Access Compliance Report

Public Rights-of-Way

(Curb Ramps)

Intersection ID: 50616	Main Street: PADDLE_OAK_RD	Cross Street: FAWN_LILY	Location: NE
ADA ID: B223D2A4855C	Ramp Type: Perp	Initial Pass/Fail: Fail	Overall Compliance: No
Severity Score: 8.75			
Codes/Mitigation Info/Possible Solution		Field Measurements/Component Compliance

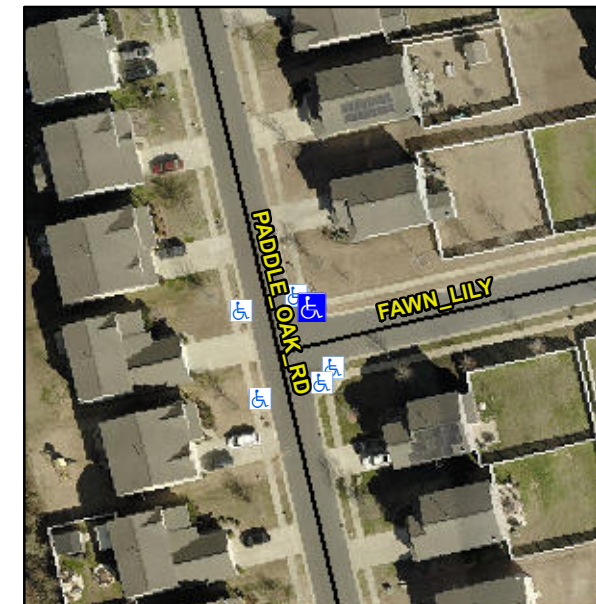
Compliance	Description	Data	Compliance	Description	Data
N/A	Ramp Length (in)	48.0	Yes	Ramp Slope (%)	7.3
No	Ramp Width (in)	47.5	Yes	Ramp XSlope (%)	0.7
N/A	Flare Type LT	N/A	N/A	Flare Type RT	N/A
N/A	Flare Slope LT (%)	N/A	N/A	Flare Slope RT (%)	N/A
N/A	Flare Traversable LT?	N/A	N/A	Flare Traversable RT?	N/A
N/A	Landing Length (in)	N/A	N/A	DWS Provided?	N/A
N/A	Landing Width (in)	N/A	N/A	DWS Contrast?	N/A
N/A	Landing Slope (%)	N/A	N/A	DWS Length (in)	N/A
N/A	Landing X Slope (%)	N/A	N/A	DWS Full Width?	N/A
N/A	Landing Curb? (Y/N)	N/A	N/A	DWS Offset (in)	N/A
N/A	Shared Landing?	N/A			
N/A	Gutter Ponding?	N/A	N/A	Gutter Slope (%)	N/A
N/A	Gutter Lip Ht (in)	N/A	N/A	Gutter X Slope (%)	N/A
N/A	Painted X Walk1?	No	N/A	Painted X Walk2?	N/A
	X Walk 1 Direction	To S		X Walk 2 Direction	N/A
N/A	X Walk 1 Width (in)	N/A	N/A	X Walk 2 Width (in)	N/A
	X Walk 1 Slope (%)	4.2		X Walk 2 Slope (%)	N/A
	X Walk 1 X Slope (%)	2.0		X Walk 2 X Slope (%)	N/A

Remove & Replace Entire Ramp.
